**City of Oakley**  
**ADDENDUM NO. 1 to contract documents for**  
**LAUREL ROAD AND ROSE AVENUE INTERSECTION IMPROVEMENT**  
**AND SIGNALIZATION PROJECT, CIP # 191**

**BID OPENING DATE: January 17, 2019 2:00 PM**

Notice is hereby given that the following clarifications and revisions are made to the above referenced contract documents:

U-3

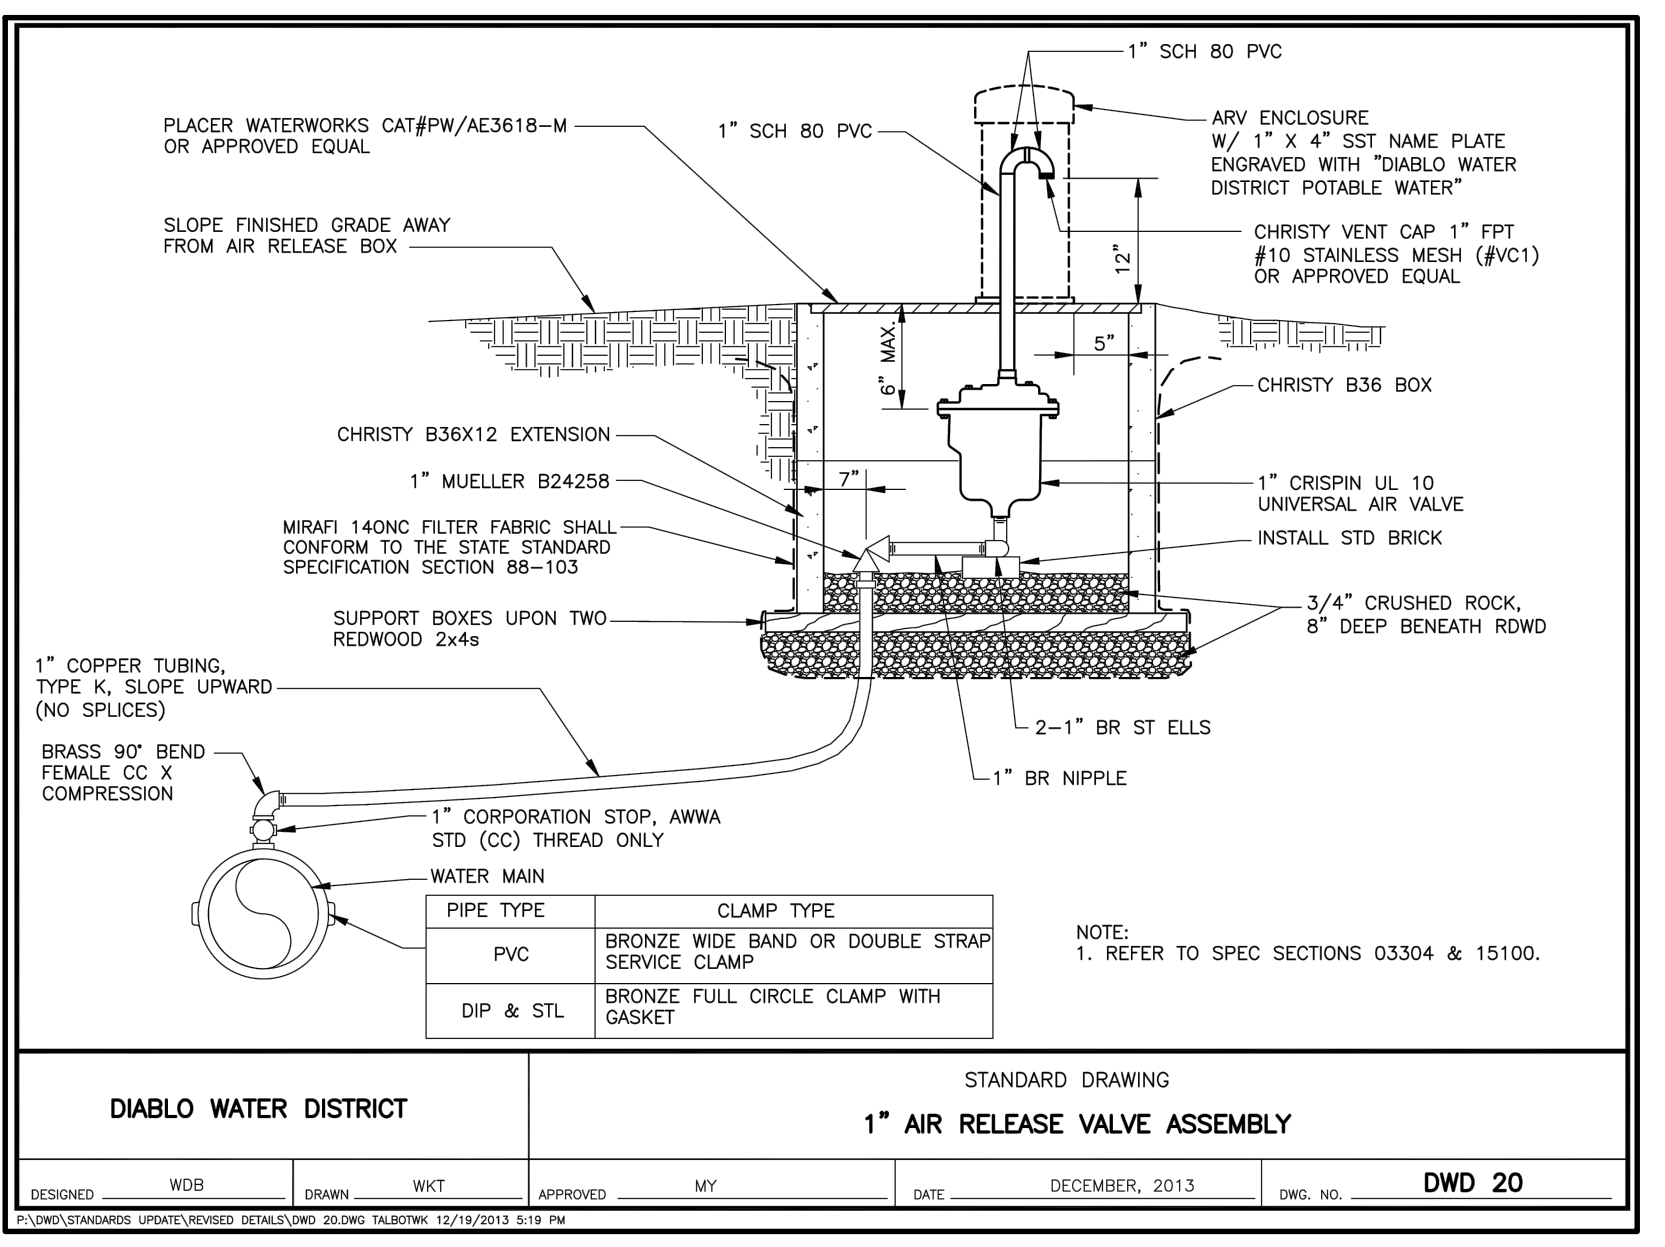
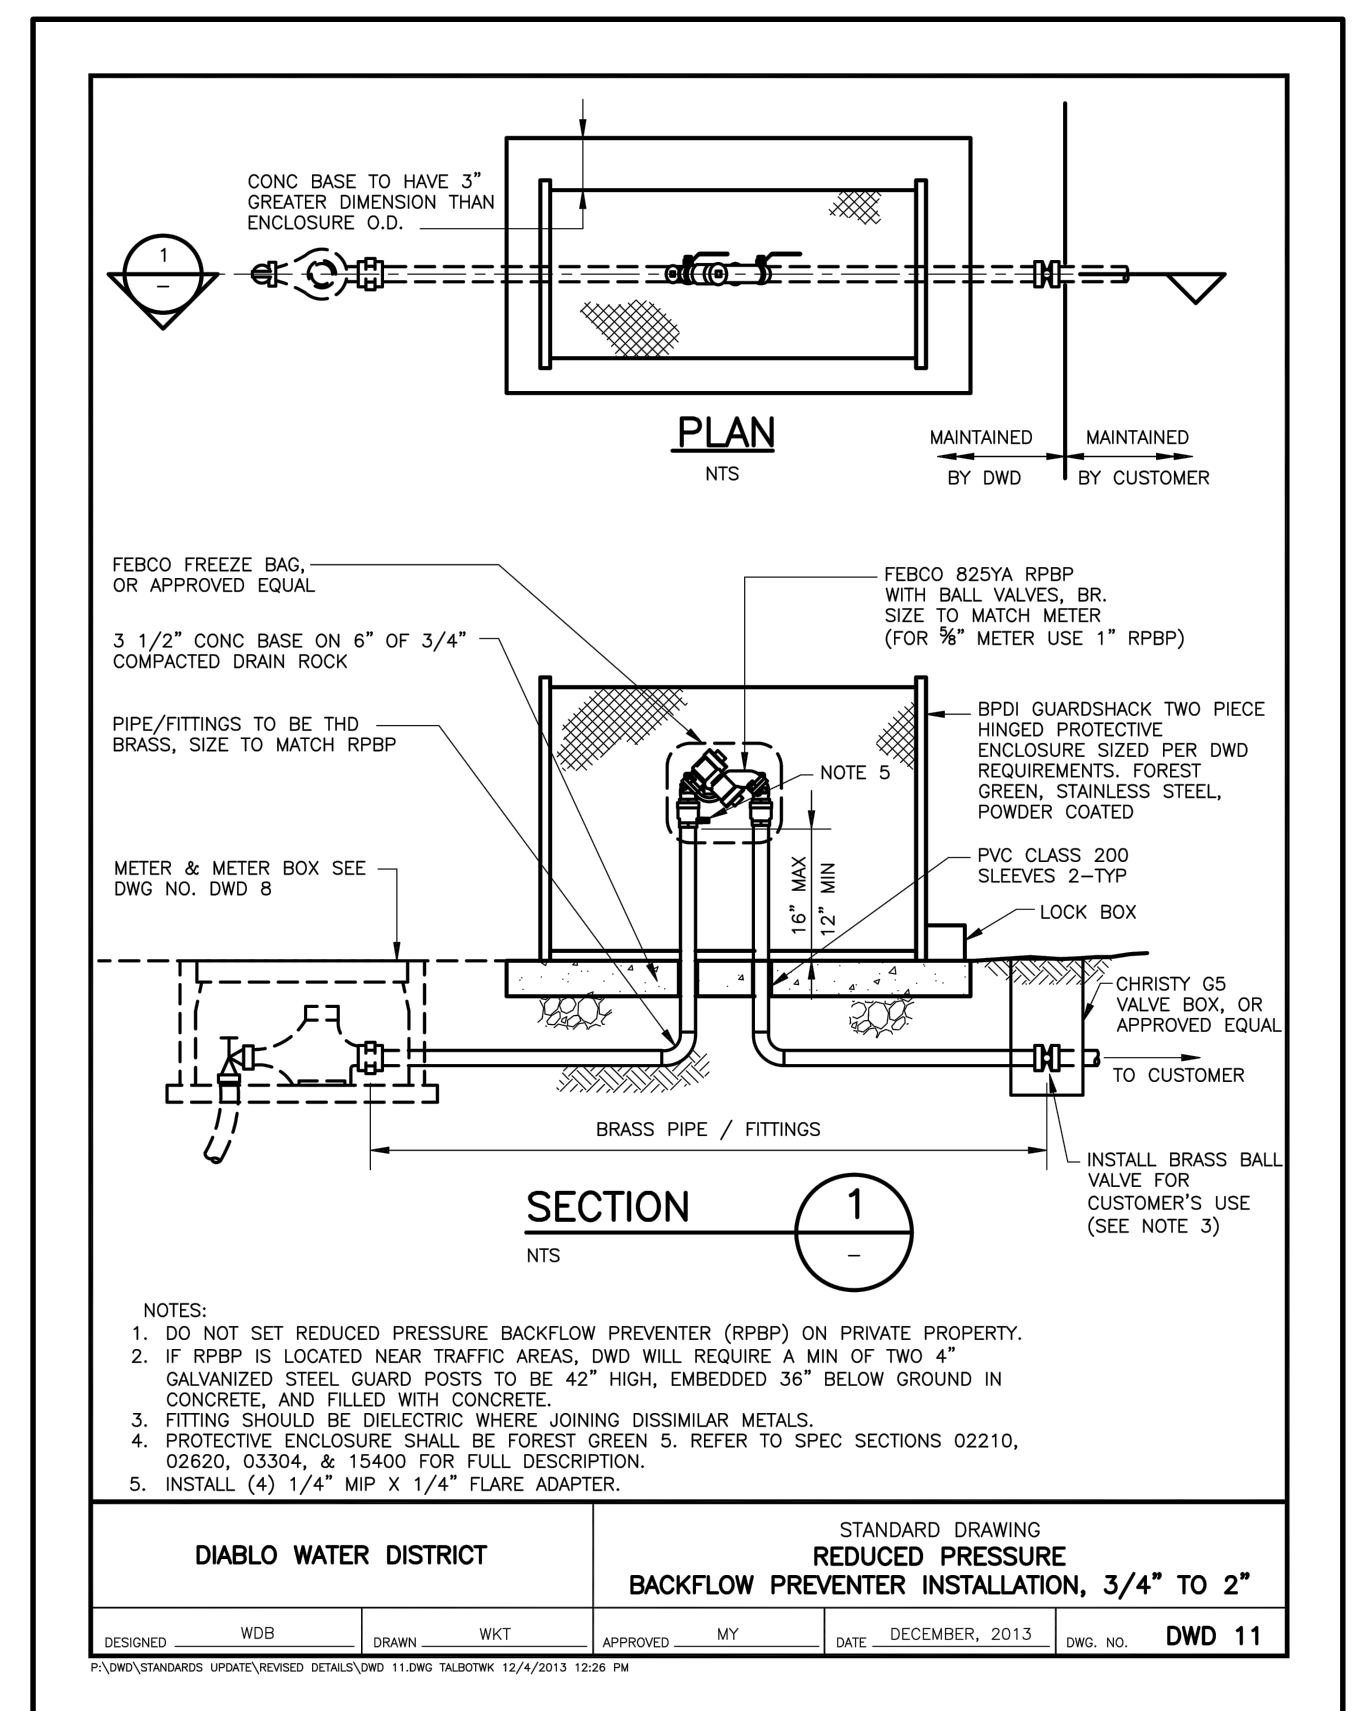
Updated Sheets CD-3, Q-1, U-1 thru U-6, E-1 and E-2
